Access Compliance Report

(Curb Ramps)

Intersection ID: 27626	Main Street: FLORAL_HALL_DR	Cross Street: JAMES JACK LN	Location: W
ADA ID: BD207F9191AA	Ramp Type: Perp	Initial Pass/Fail: Fail	Overall Compliance: No
Severity Score: 8.75			
Codes/Mitigation Info/Possible Solution		Field Measurements/Component Compliance

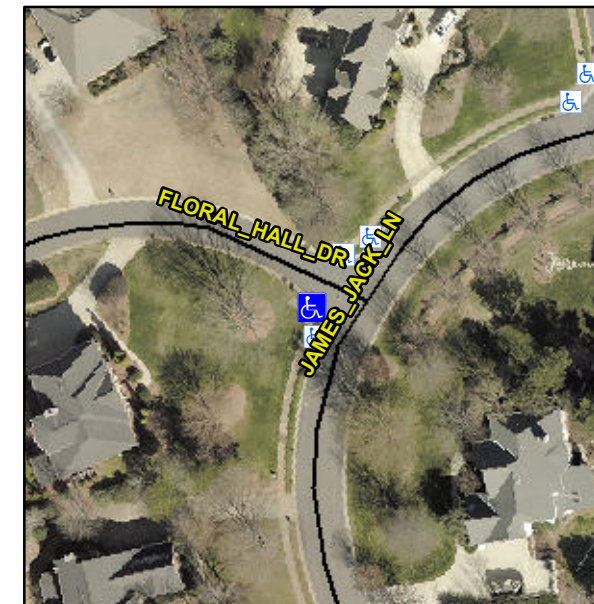
Not Found, R304.5.1

Compliance	Description	Data	Compliance	Description	Data
N/A	Ramp Length (in)	47.0	Yes	Ramp Slope (%)	5.1
No	Ramp Width (in)	38.0	Yes	Ramp XSlope (%)	0.1
N/A	Flare Type LT	N/A	N/A	Flare Type RT	N/A
N/A	Flare Slope LT (%)	N/A	N/A	Flare Slope RT (%)	N/A
N/A	Flare Traversable LT?	N/A	N/A	Flare Traversable RT?	N/A
N/A	Landing Length (in)	N/A	N/A	DWS Provided?	N/A
N/A	Landing Width (in)	N/A	N/A	DWS Contrast?	N/A
N/A	Landing Slope (%)	N/A	N/A	DWS Length (in)	N/A
N/A	Landing X Slope (%)	N/A	N/A	DWS Full Width?	N/A
N/A	Landing Curb? (Y/N)	N/A	N/A	DWS Offset (in)	N/A
N/A	Shared Landing?	N/A			
N/A	Gutter Ponding?	N/A	N/A	Gutter Slope (%)	N/A
N/A	Gutter Lip Ht (in)	N/A	N/A	Gutter X Slope (%)	N/A
N/A	Painted X Walk1?	No	N/A	Painted X Walk2?	N/A
	X Walk 1 Direction	To NE		X Walk 2 Direction	N/A
N/A	X Walk 1 Width (in)	N/A	N/A	X Walk 2 Width (in)	N/A
	X Walk 1 Slope (%)	0.5		X Walk 2 Slope (%)	N/A
	X Walk 1 X Slope (%)	1.2		X Walk 2 X Slope (%)	N/A

Remove & Replace Entire Ramp.
